Subject: S.P. 2774-27504A  
Bridge No. 27504  
Revised Plan Sheets

Subject: S.P. 2774-16  
Bridge No. 27504  
Revised Plan Sheets

## Addendum 1 for changes to the Plans and Special Provisions for Bridge Nos. 7268 and 27504:

DES: RJR DR: BEP APPROVED: 5/29/13  
 CHK: GBB CHK: TRS  
 SHEET NO. 11R OF 34 SHEETS

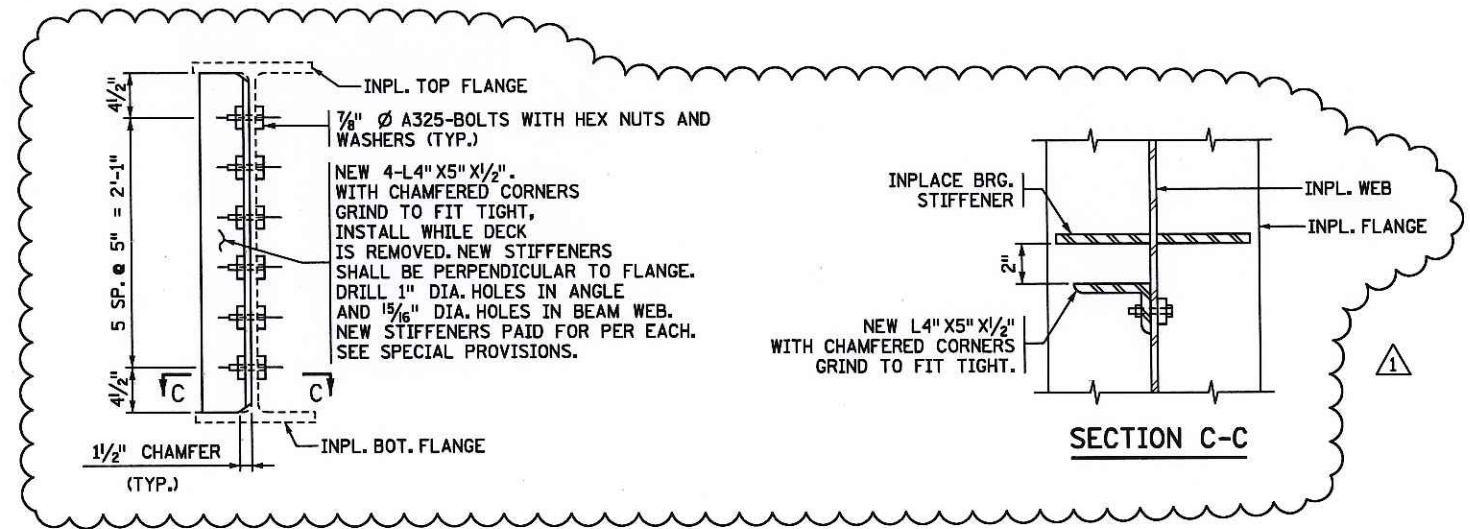
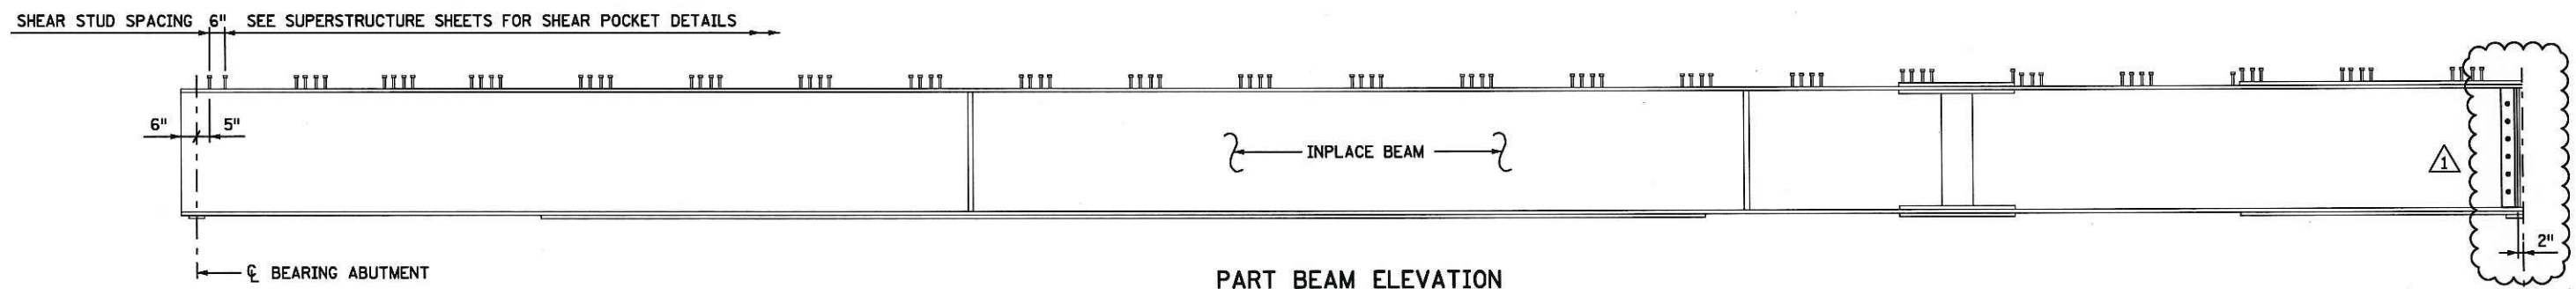
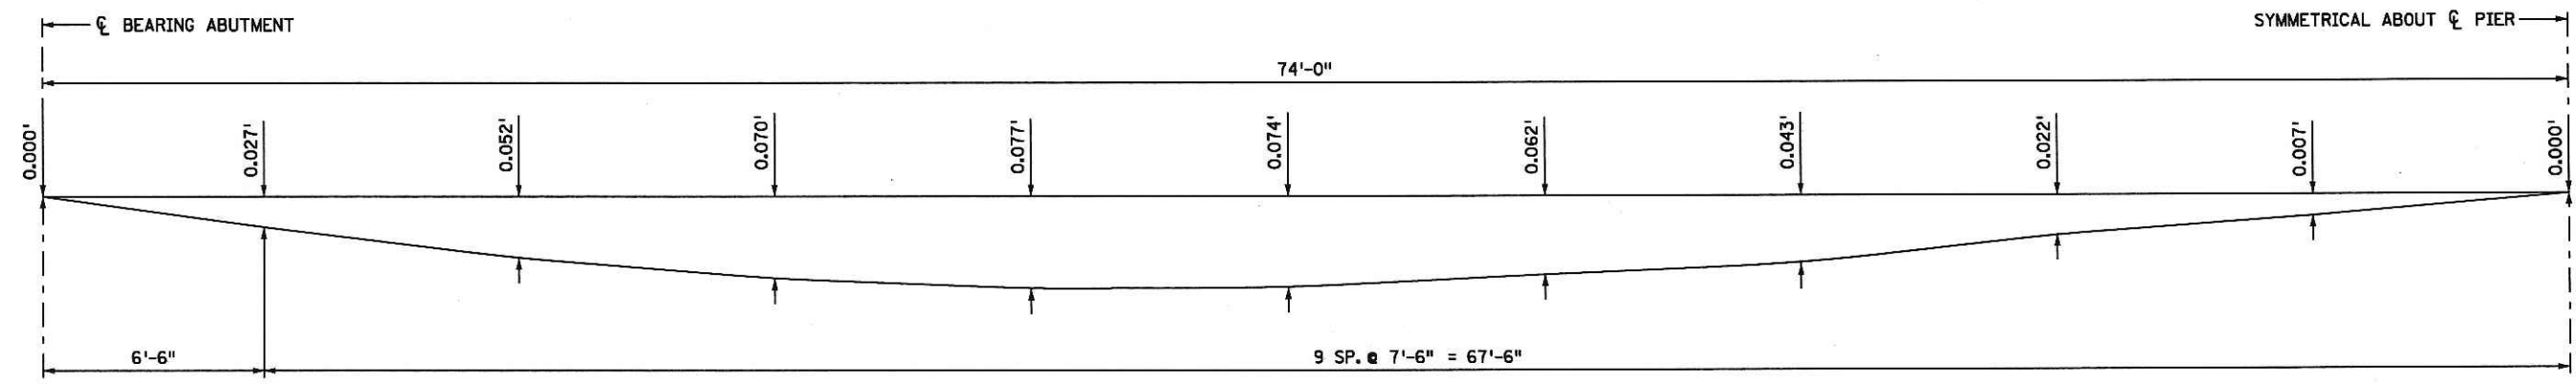
15) On Sheet 11R of 34 for Bridge No. 27504 the following changes were made:

- a. Added beam stiffener angle details.

DES: RJR DR: RLS APPROVED: 5/29/13  
 CHK: GBB CHK: TRS  
 SHEET NO. 12R OF 34 SHEETS

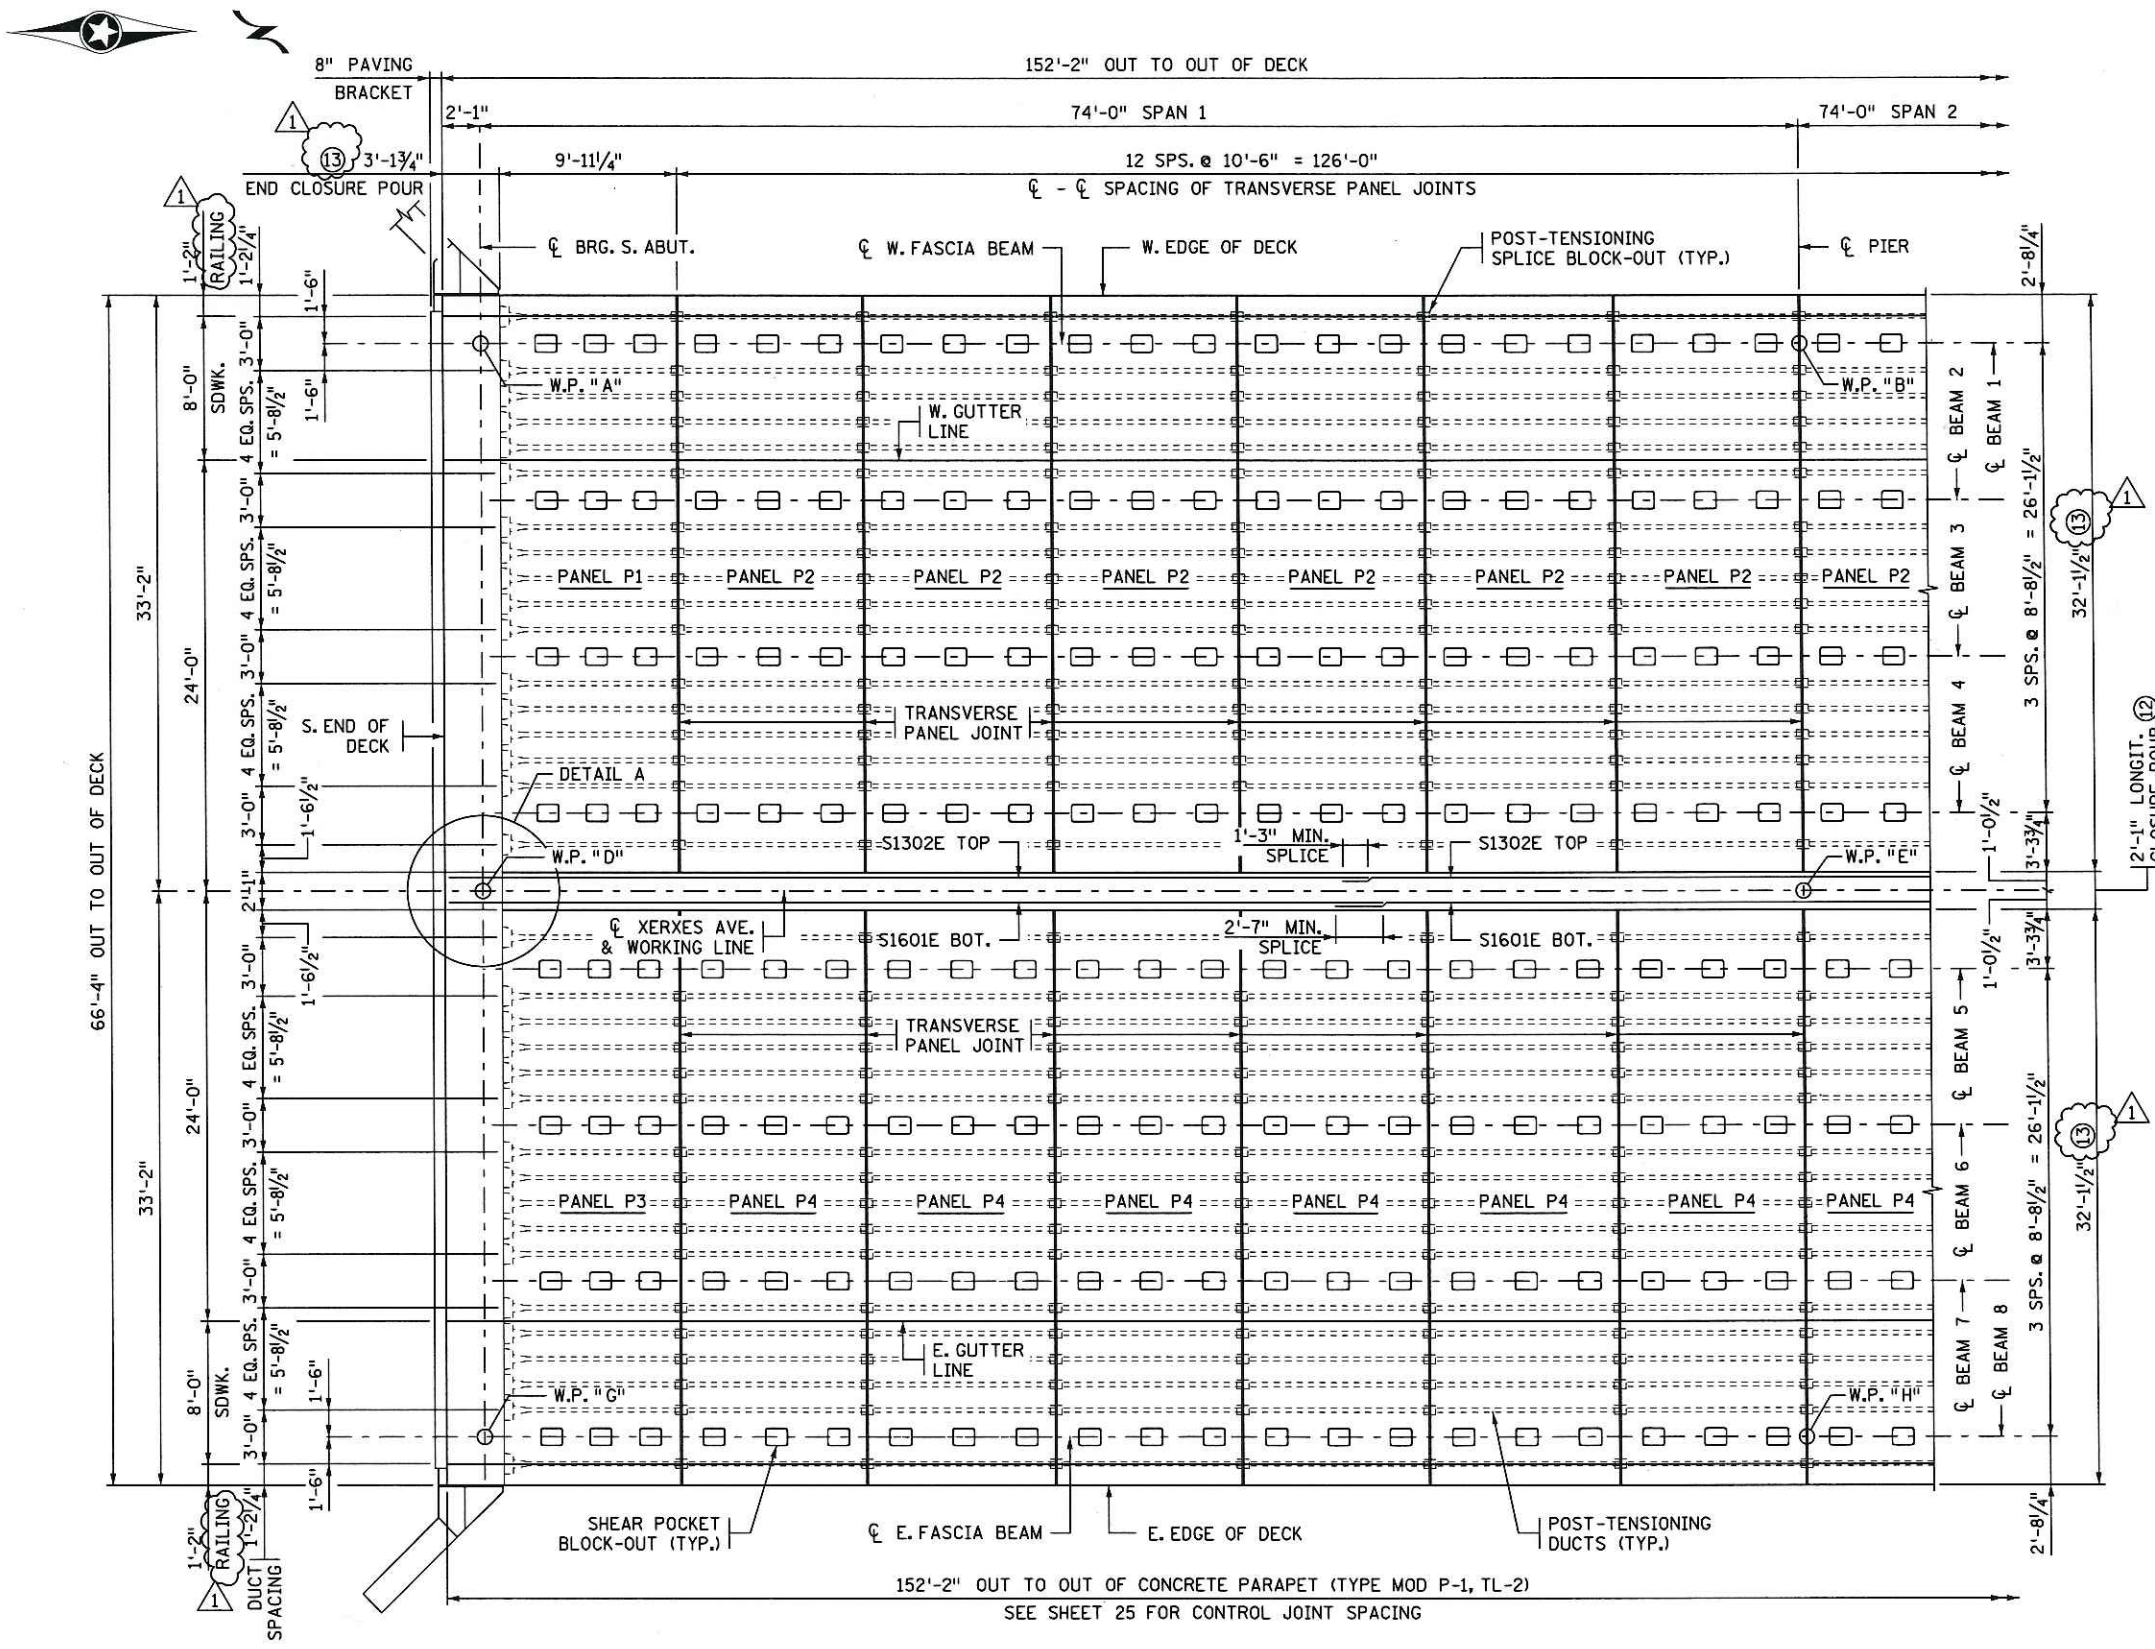
16) On Sheet 12R of 34 for Bridge No. 27504 the following changes were made:

- a. Added quantity for beam stiffeners in "Summary of Quantities".
- b. Revised circle note 12.
- c. Added circle note 13.
- d. Clarified 1'-2" dimension in "Partial Deck Plan".

DES: RJR DR: RLS APPROVED: *5/29/13*  
 CHK: GBB CHK: TRS  
 SHEET NO. 13R OF 34 SHEETS

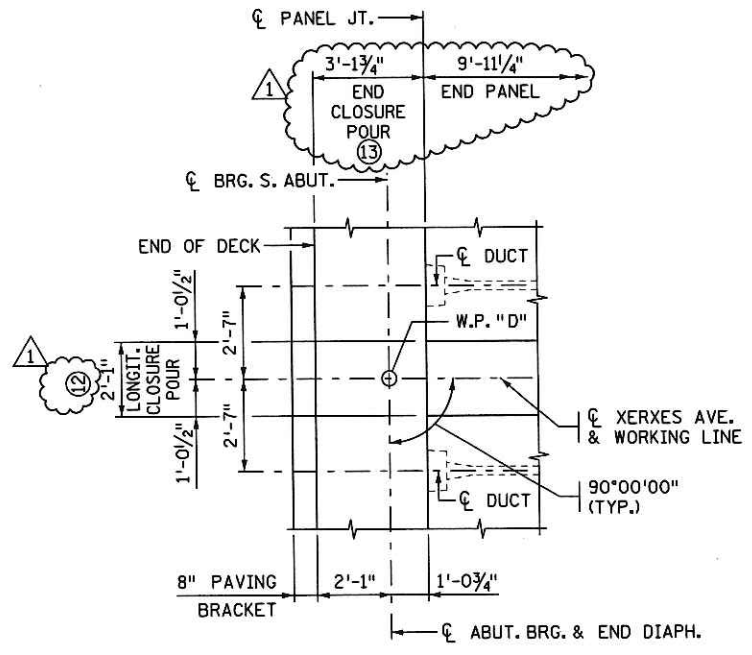
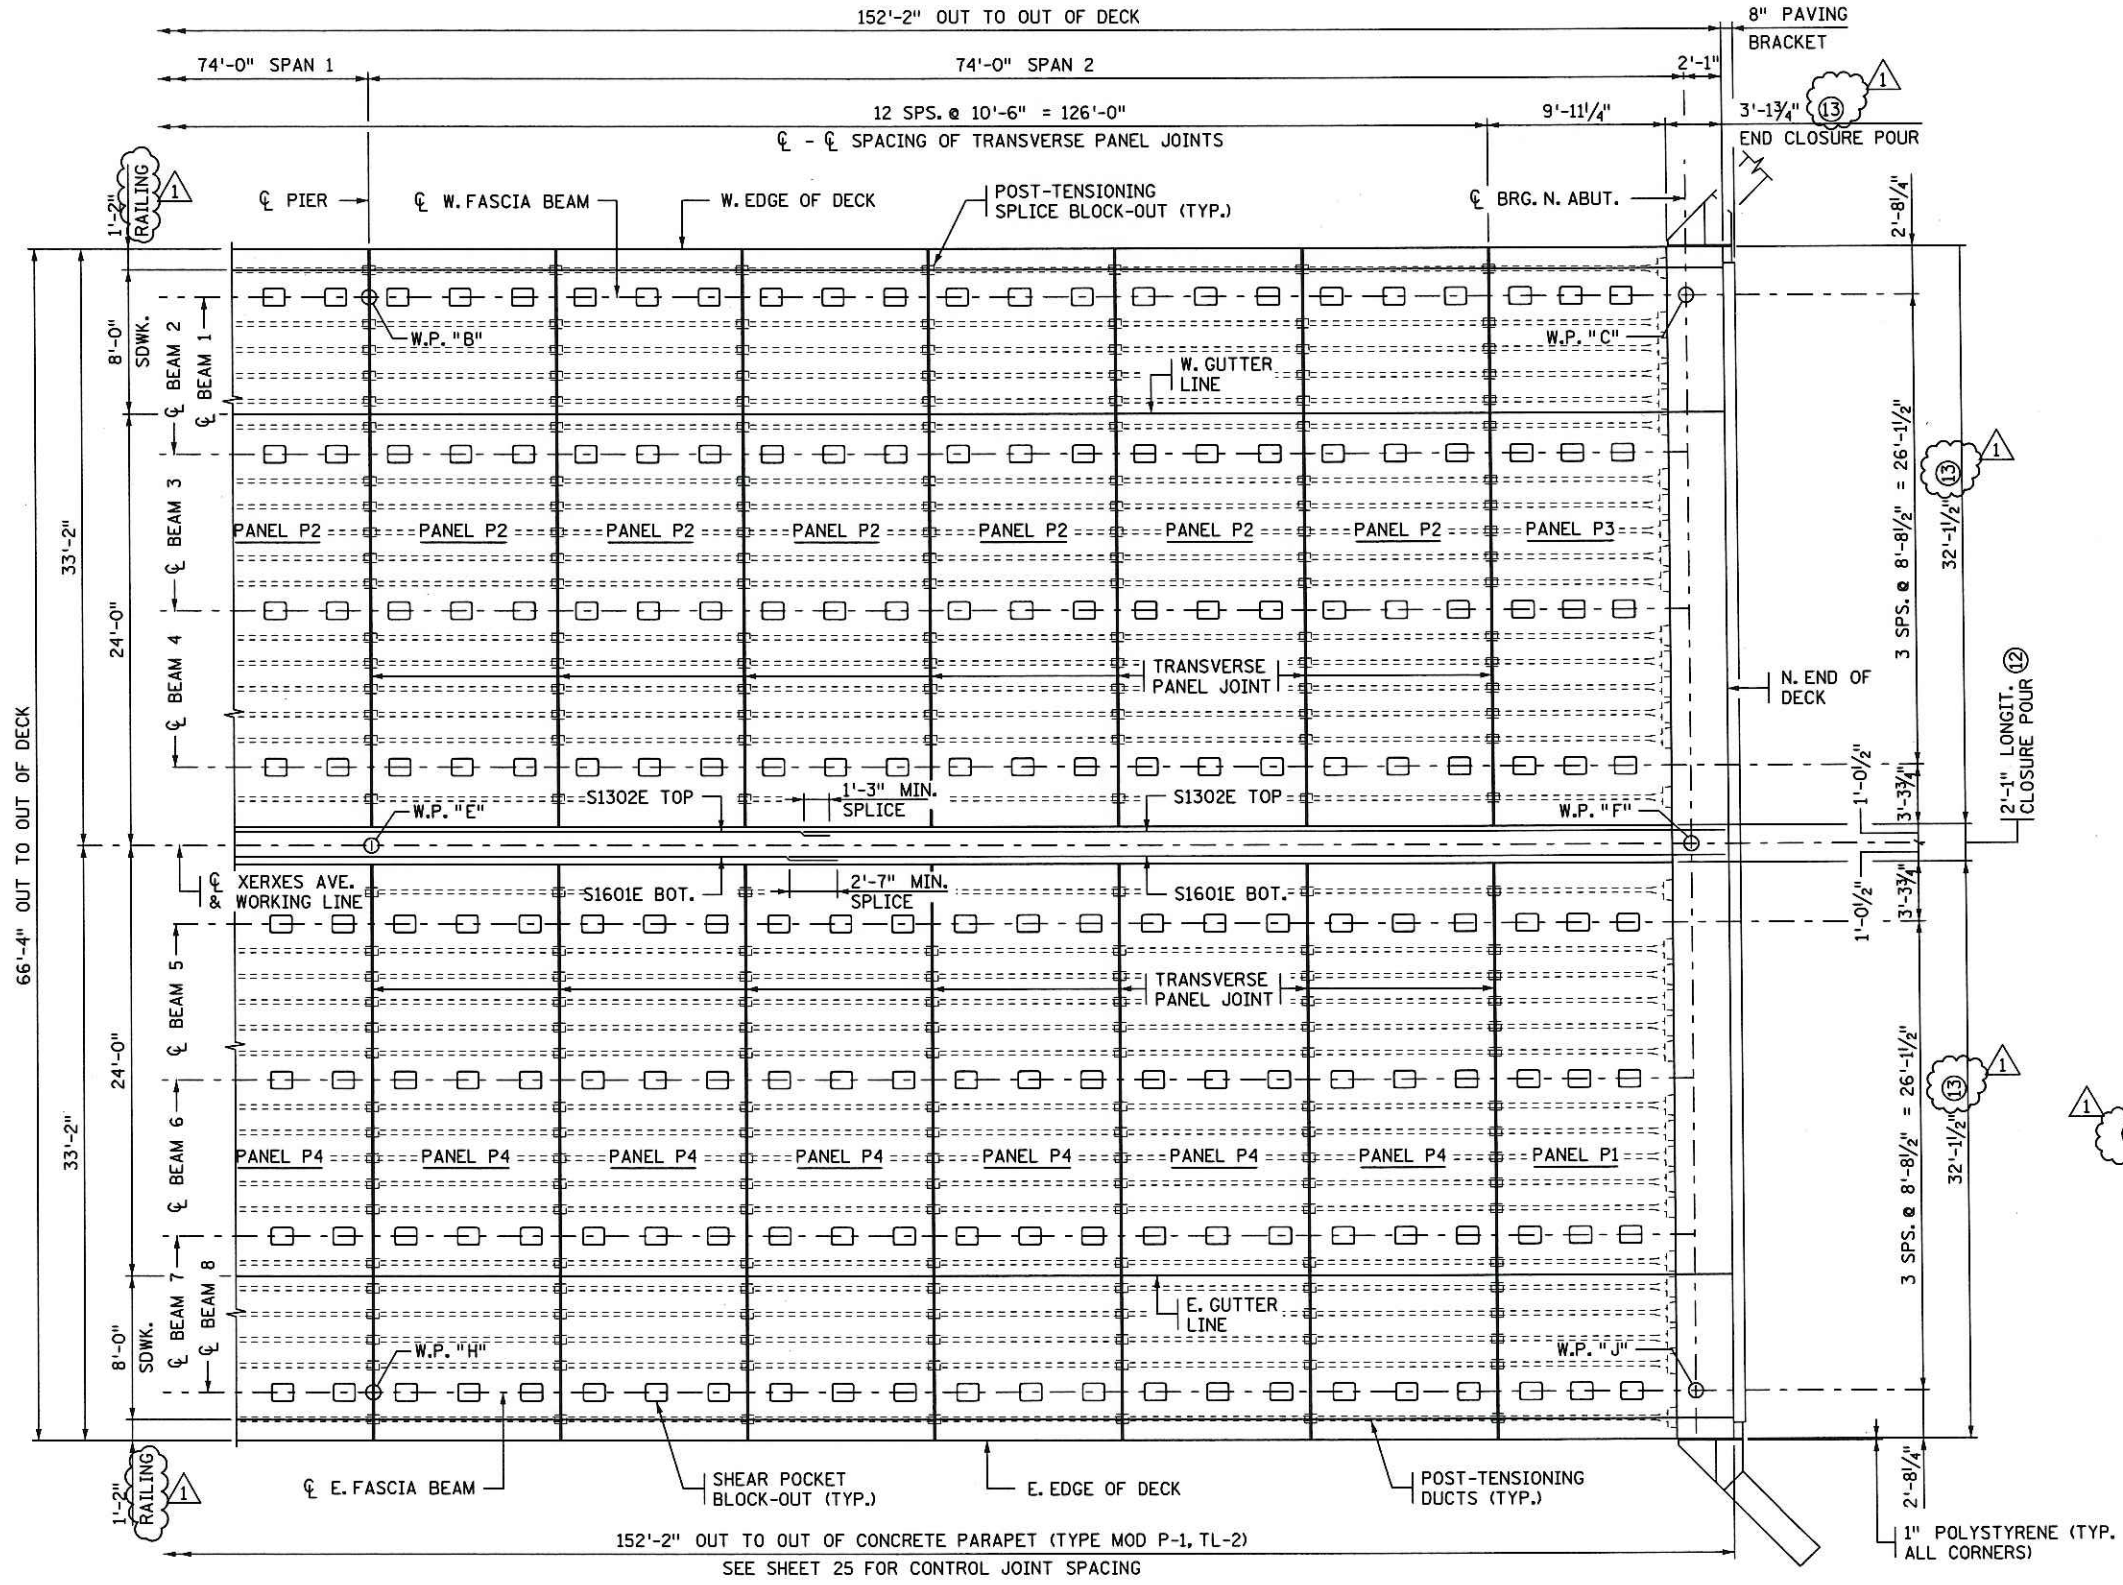
17) On Sheet 13R of 34 for Bridge No. 27504 the following changes were made:

- a. Revised circle note 12.
- b. Added circle note 13.
- c. Clarified 1'-2" dimension in "Partial Deck Plan".
